14. DESCRIPTION OF AMENDMENT/MODIFICATION (Organized by UCF section headings, including solicitation/contract subject matter where feasible.) Amendment No. 0004 to DACA65-02-R-0041, F-22 Storm Drainage, Langley Air Force Base, VA.				
Except as provided herein, all terms and conditions of the document referenced in Item 9A or 10A, as heretofore changed, remains unchanged and in full force and effect.				
15A. NAME AND TITLE OF SIGNER (Type or print)		16A. NAME AND TITLE OF CONTRACTING OFFICER (Type or print)		
		TEL: _____ EMAIL: _____		
15B. CONTRACTOR/OFFEROR	15C. DATE SIGNED	16B. UNITED STATES OF AMERICA	16C. DATE SIGNED	
_____ (Signature of person authorized to sign)		BY _____ (Signature of Contracting Officer)	19-May-2003

1. Proposal due date is hereby extended to May 29, 2003 at 11:00 pm. Phase II proposals are to be submitted to US Army Engineer District, Norfolk, 803 Front Street, ATTN: CENAO-SS-C, Norfolk, VA 23510-1096.
2. Technical specifications and drawings are amended in accordance with the attached.

CIVIL
 F-22 INFRASTRUCTURE AND
 STORM SEWER UPGRADES
 SK011

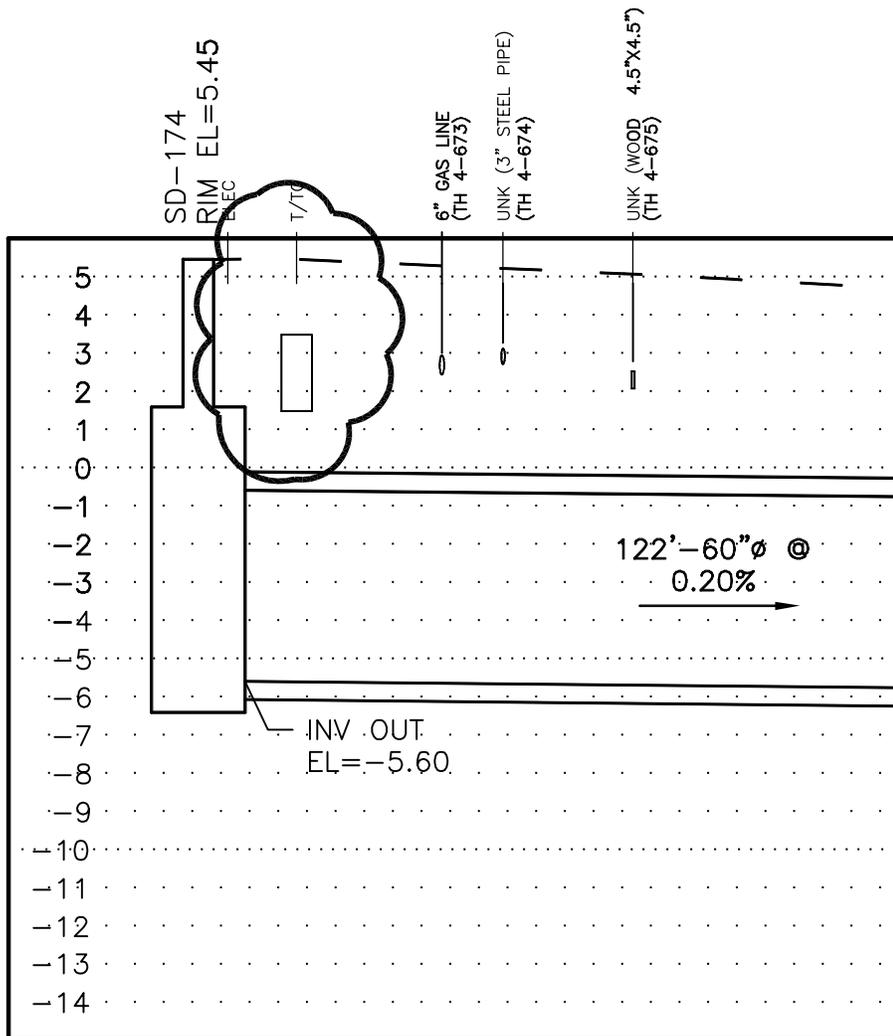
CONNECT 8'x6' BOX CULVERT TO PROPOSED STRUCTURE WITH 6'x6' BOX TO 8'x6' BOX PRECAST REDUCER.

CIVIL
F-22 INFRASTRUCTURE AND
STORM SEWER UPGRADES
SK012

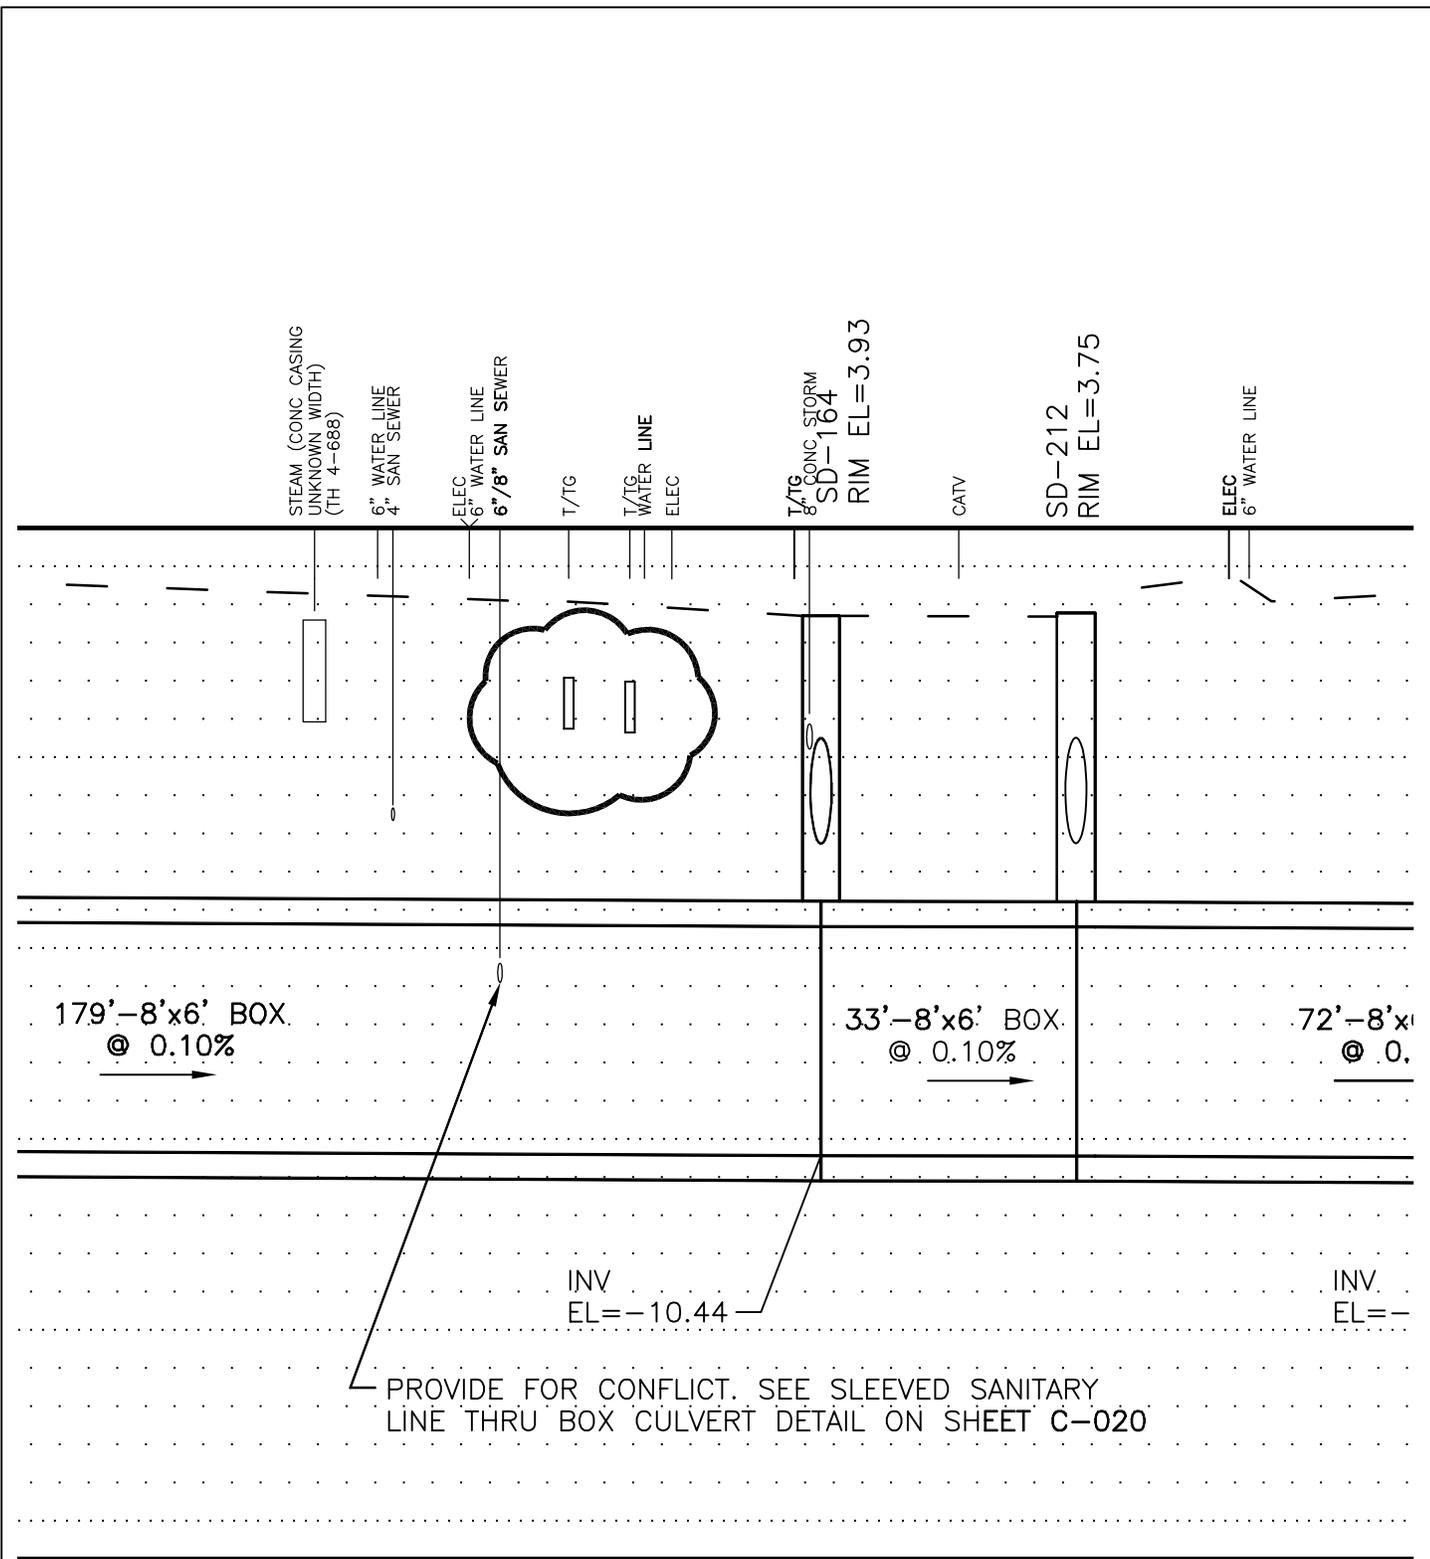
179'-8'x6' BOX.
@ 0.10%

33'-8'x6' BOX.
@ 0.10%

72'-8'x6' BOX.
@ 0.

CIVIL
F-22 INFRASTRUCTURE AND
SEWER UPGRADES
SK013

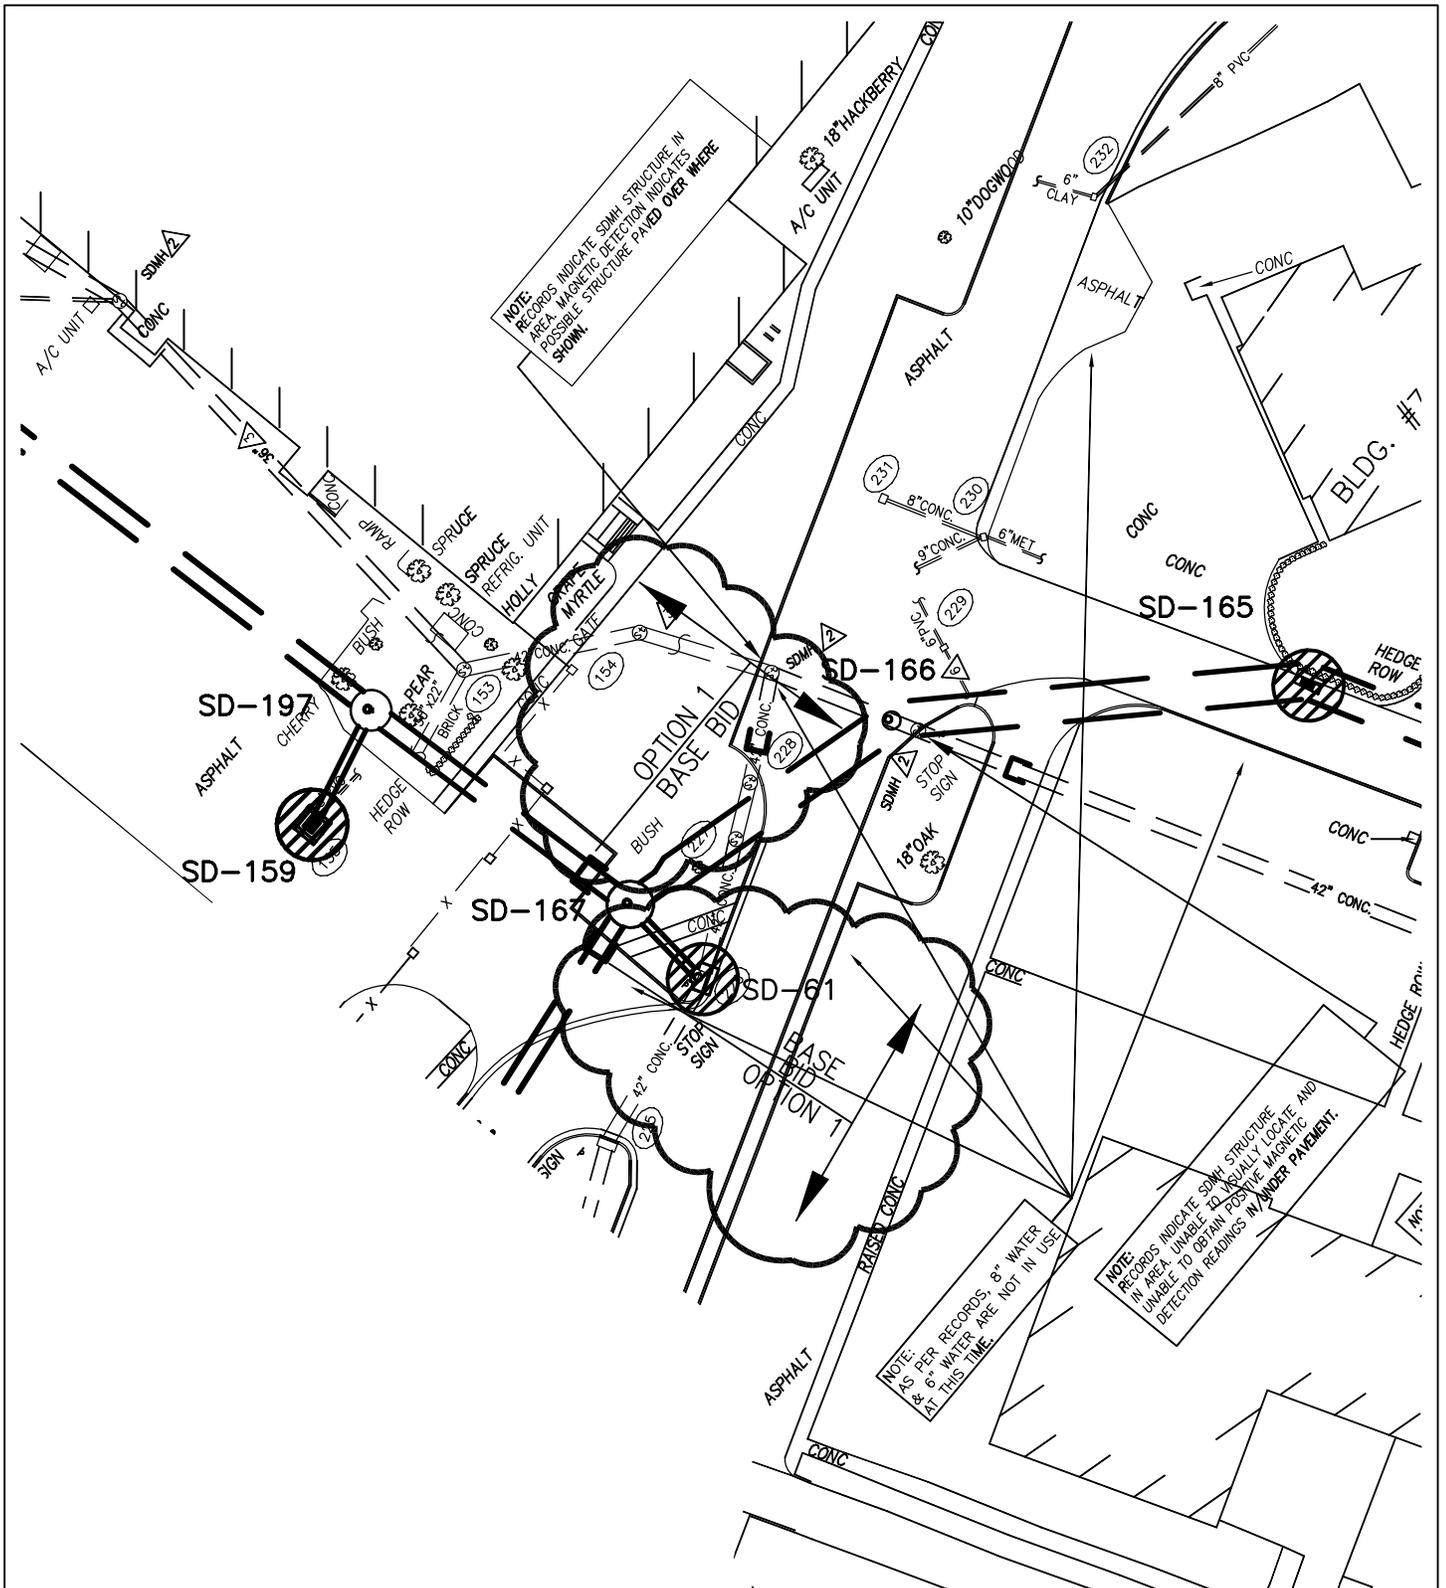
PROVIDE FOR CONFLICT. SEE SLEEVED SANITARY
LINE THRU BOX CULVERT DETAIL ON SHEET C-020
